Our Ref: MEW: L.N1514.005

16 December 2010

RE: MYALL RIVER DOWNS, TEA GARDENS – ADDITIONAL REVIEW OF FLOODING, STORMWATER AND GROUNDWATER ASSESSMENTS

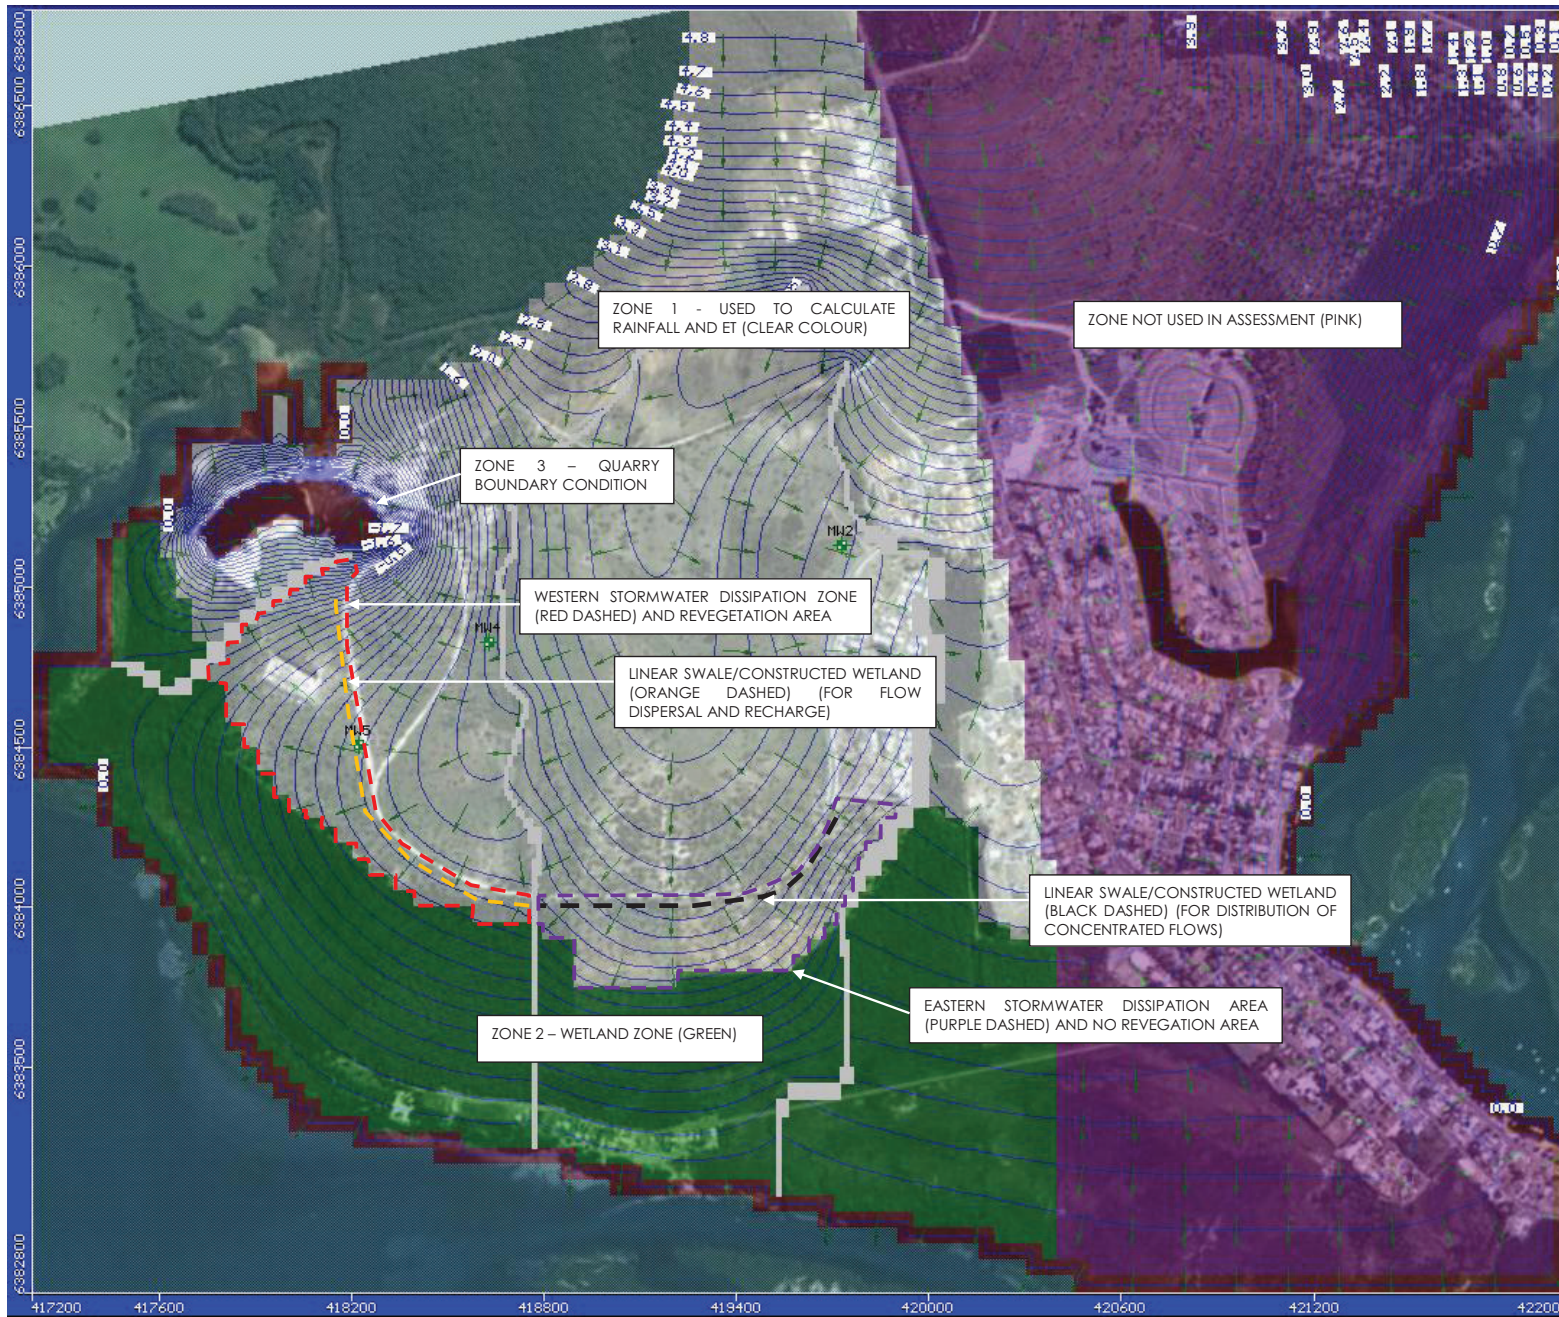
1. A new groundwater MODFLOW model (M4) was developed. This distributed the 529 ML/yr flow increase over the western and eastern stormwater dissipation zones (Figure 1) as additional recharge.
2. Change in net annual areal ET over the western and eastern stormwater dissipation zones (in M4) was based on existing and revegetated crop factors (Table 3) resulting in an ET increase of 568 mm/yr and 258 mm/yr respectively.
3. The 529 ML/year distribution swale inflow was apportioned such that 63% was directed west and 37% was directed east in order to account for varying ET rates. An appropriate flow distribution design would be required to achieve this.

BMT WBM consider the proposed linear constructed wetland (Figure 2 of the June advice) to be a favourable strategy for mitigation of the impacts of this increase in concentrated surface water discharge. It is a strategy that attempts to mimic the natural hydrology of the site and utilise the flow and pollutant buffering capacity of the Climate Change Transition Zone. The potential benefits of this measure have been estimated through steady state modelling of the impacts on groundwater levels however a more refined assessment will be necessary at a later stage that includes continuous, dynamic modelling of measure performance for critical design events in addition to long-term implications.

Marfens & Associates Pty Ltd		ABN 85 070 240 890	Environment Water Wastewater Geotechnical Civil Management	
Drawn:	BR		MODEL M4 DRAWDOWN FROM MODEL M1A GROUNDWATER HEAD	Drawing No:
Approved:	DM			FIGURE 2
Date:	20.06.2011			
Scale:	1:16,660 Approx			Job No: P0902346

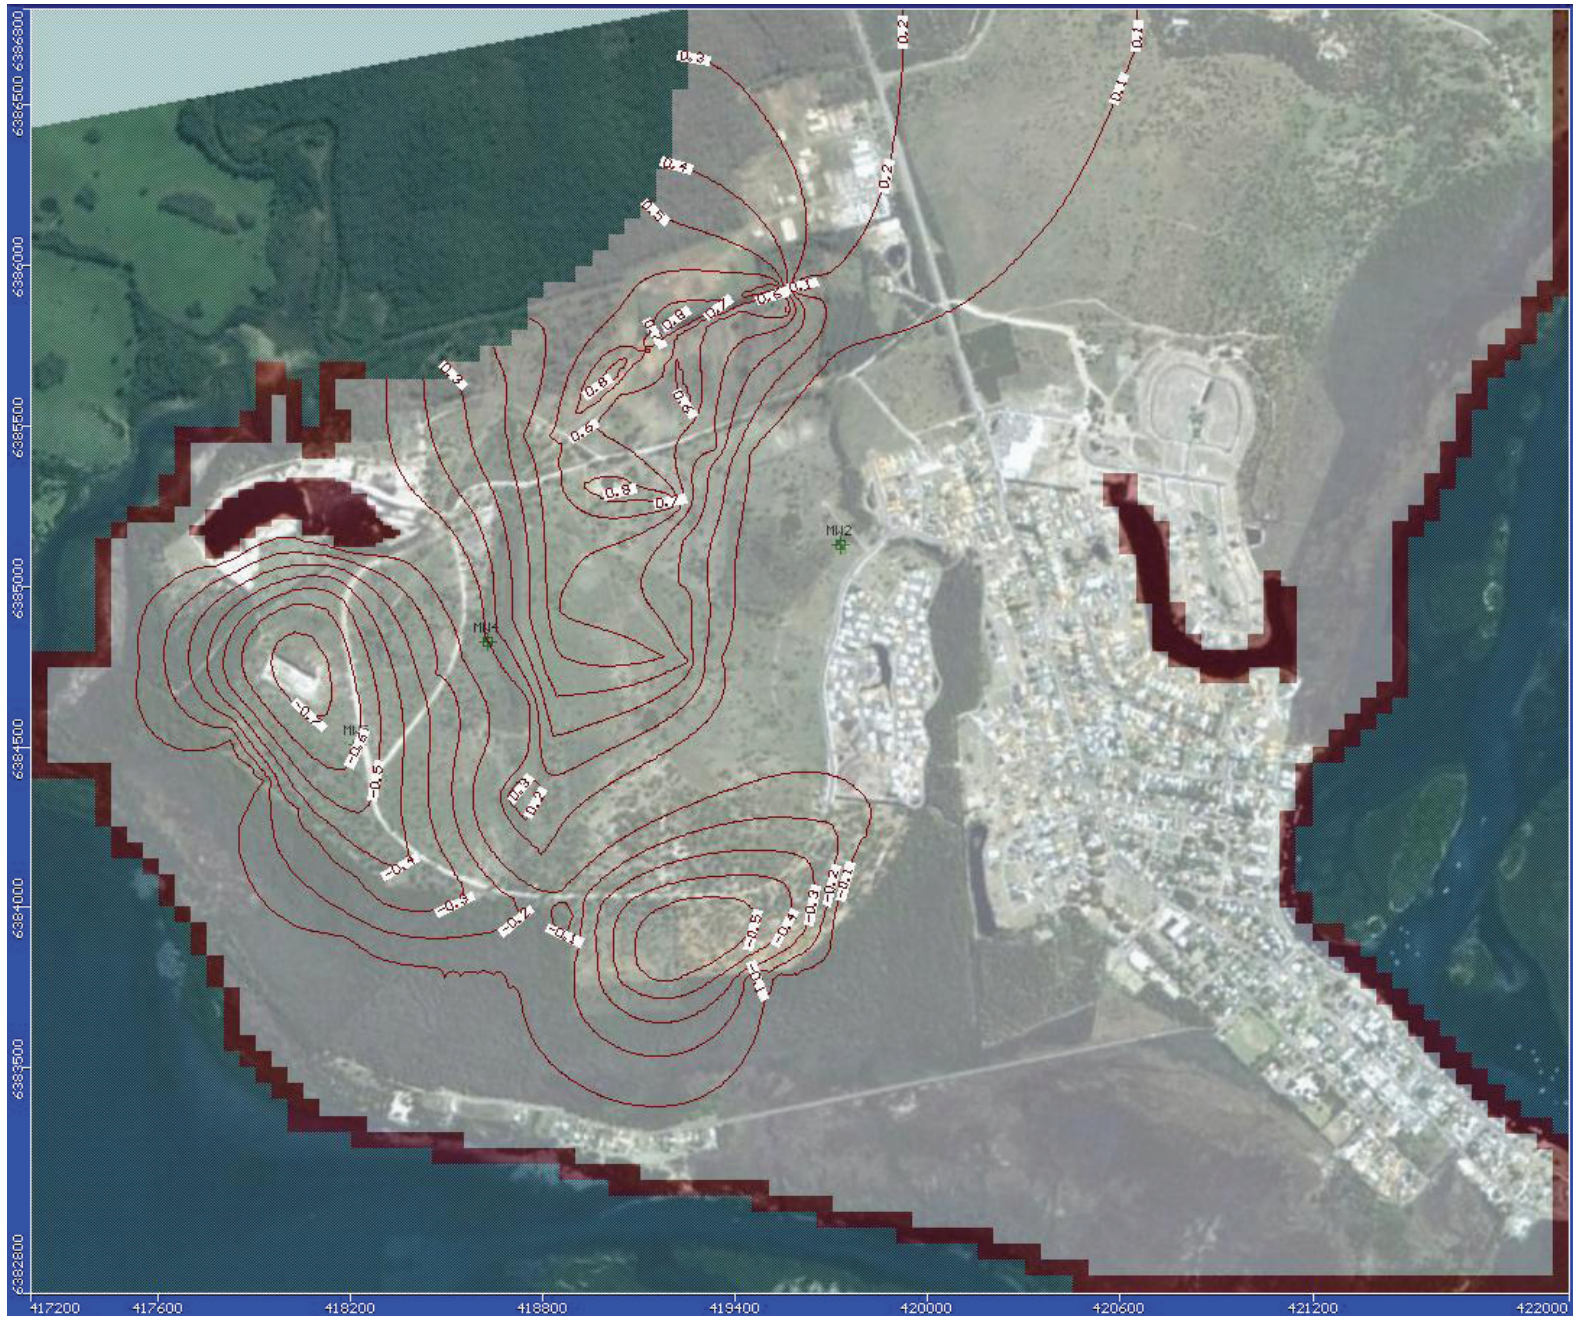
A drawdown plot for M4 (using M1a as initial heads surface) indicates that there may be some minor increases to groundwater levels over the northern wetland interface with the stormwater dissipation zones. However, these increases are small and within the expected day to day groundwater fluctuation levels found within the wetland. The proposed remediation option therefore provides a suitable mechanism by which any potential impacts of point source surface water discharges to the wetlands can be mitigated against.

The 529 ML/year net change in average annual surface discharge to the wetland was applied to a new (M4) MODFLOW model as concentrated recharge along the proposed linear constructed wetland location to assess the potential impact on groundwater levels and drain discharge volumes. The resulting drawdown plot of steady state groundwater levels is shown in Figure 2 of this 20th June letter report.
